Grid Code Administrator Consultation Response Proforma

GC0127 & GC0128 – EU Code Emergency & Restoration: Requirements resulting from System Restoration and Defence Plans

Figure 1

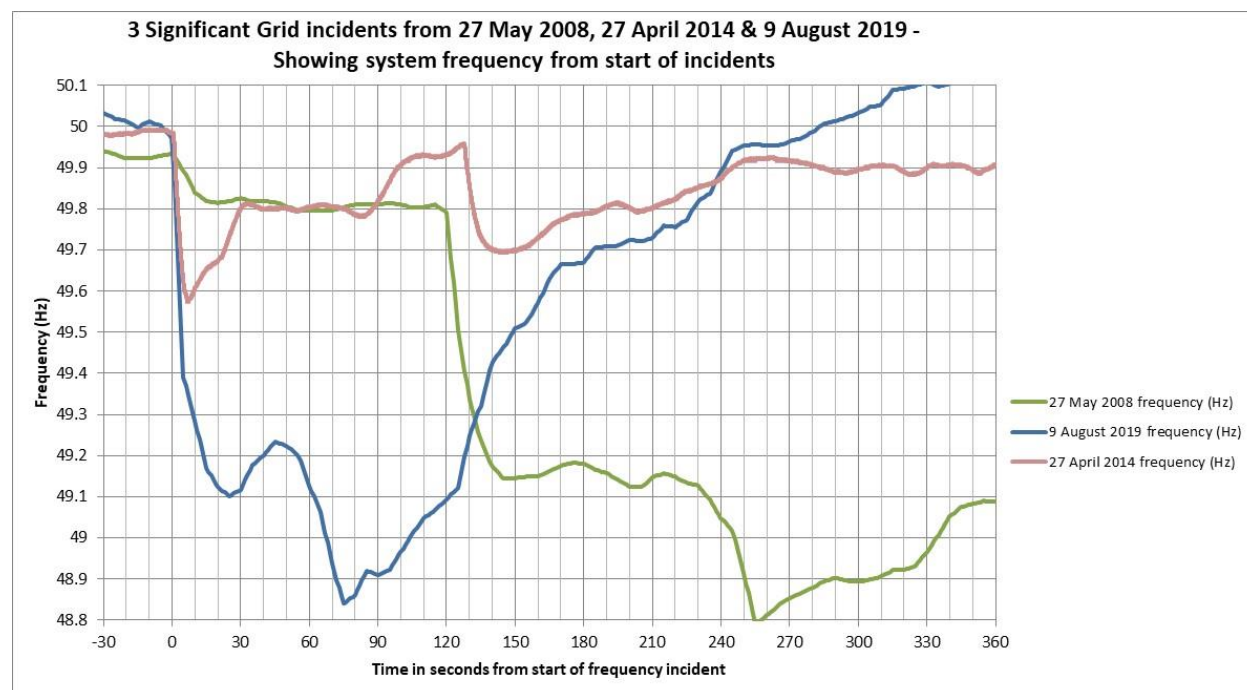
To answer this question, it is best to review three of the largest frequency drops caused by two generating units tripping off in quick succession in recent times. These events include the last 2 occasions when the system frequency has dropped below 48.8Hz on the 27 May 2008 and 19 August 2019 and another frequency drop on the 27 April 2014. Traces of the 3 frequency responses against

time are shown in figure 1 below, note the data logging rates are approximately every 5 second for 27 May 2008 and 19 August 2019 and 20ms for the 27 April 2014.

Figure 2

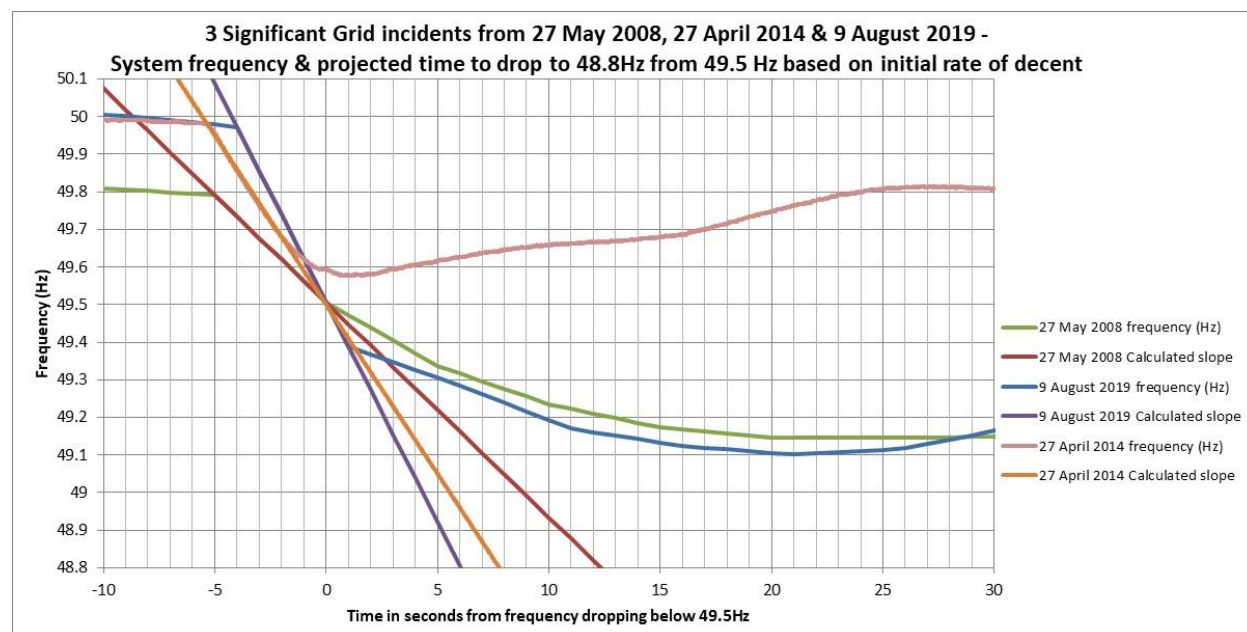
In an attempt to try and establish acceptable response time figure 2 shows the actual frequency traces and has used the first 2 data points of each trace to predict the initial slope and then estimates if this rate of frequency decrease had been continued how long it would take the frequency to reach 48.8Hz from the point it passed below 49.5Hz, note the time axis has now been zeroed at the point the frequency trace drops below 49.5Hz.

Looking at figure 2 it can be seen that the three events predict that if the rate of frequency drop was to continue at the original rate it would take either 6s, 8s or 12s to drop the frequency from 49.5 Hz to below 48.8Hz, so it could be suggested that a response within 6 seconds would potentially

guarantee the power flow would be reversed in time. It should be noted, however there could be a bigger system event and hence the 6 second still might not be quick enough.

Figure 3

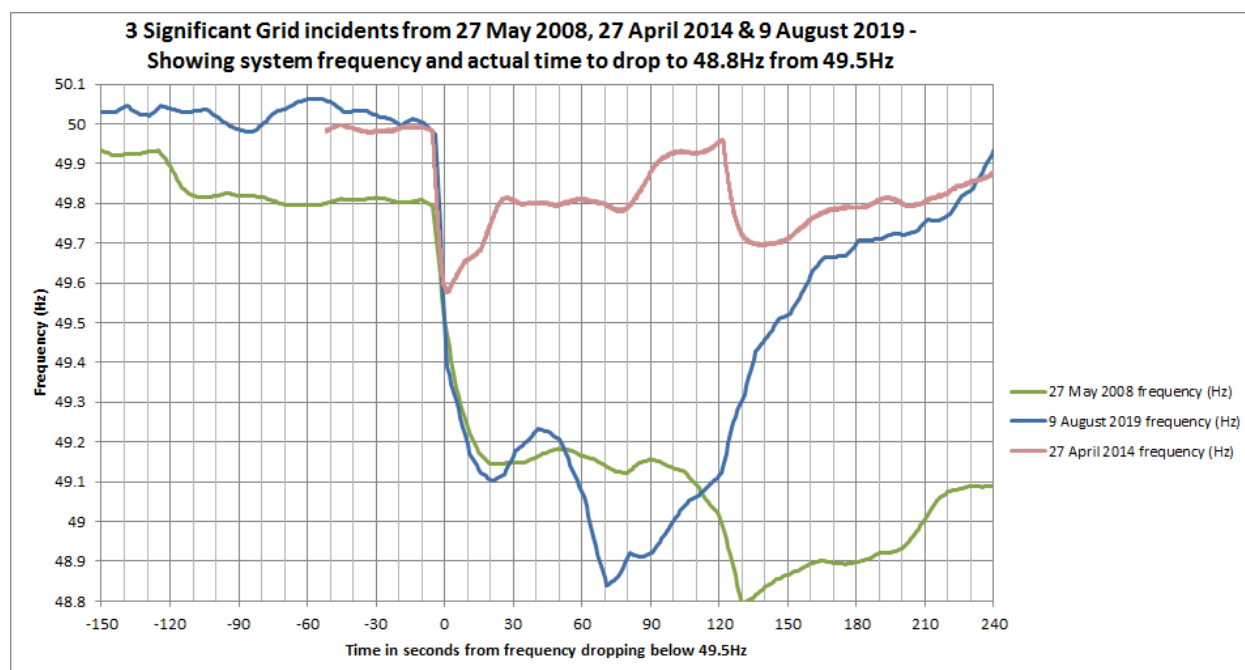
An alternative approach is to look at the two events where the frequency has actually dropped below 48.8Hz as shown in figure 3 below.

During these events it can be seen that after the frequency drops below 49.5Hz it actually took approximately 70 seconds on the 9 August 2019 and 130 seconds on the 27 May 2008 (note due to logging rate no points are recorded below 48.8Hz), so potentially it would be better for real events if the timescale was longer giving a greater time for more Electricity Storage Modules to reverse and hence giving more recovery response to the system. From figure 3 the permitted time for Electricity Storage Modules to reverse could potentially be as long as a minute but probably 20 second would be better.

Figure 4 - WACM2 Electricity Storage Module acceptable zone for response characteristic

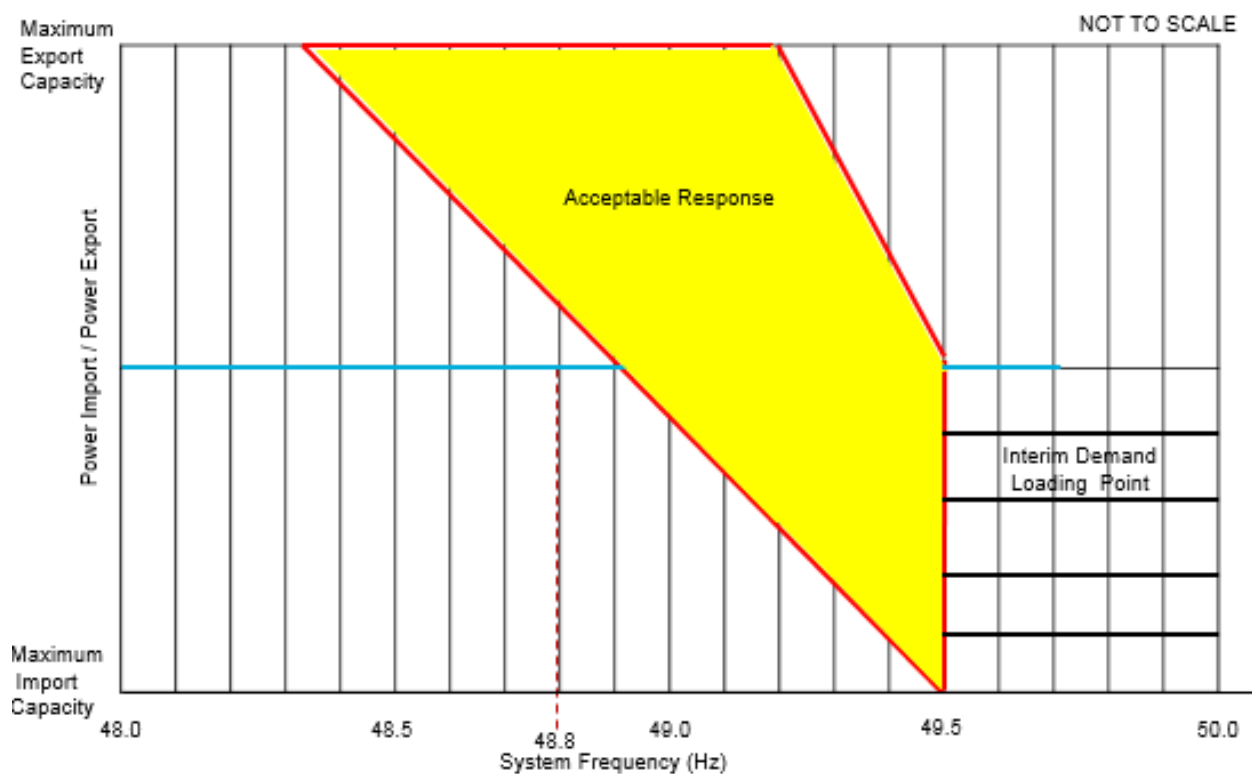
Finally the response from an Electricity Storage Module needs to be proportionate to the frequency drop as required in ECC.6.3.7(g) and must fall with the yellow shaded area of figure 4 with the area

being defined by the response needing to be above 0MW at 48.9Hz which is the trip point at one extreme. Equally the response must not be so rapid such that it could cause system instability, hence the other extreme of the yellow shaded area only allows full power output after the frequency has dropped below 49.2Hz.
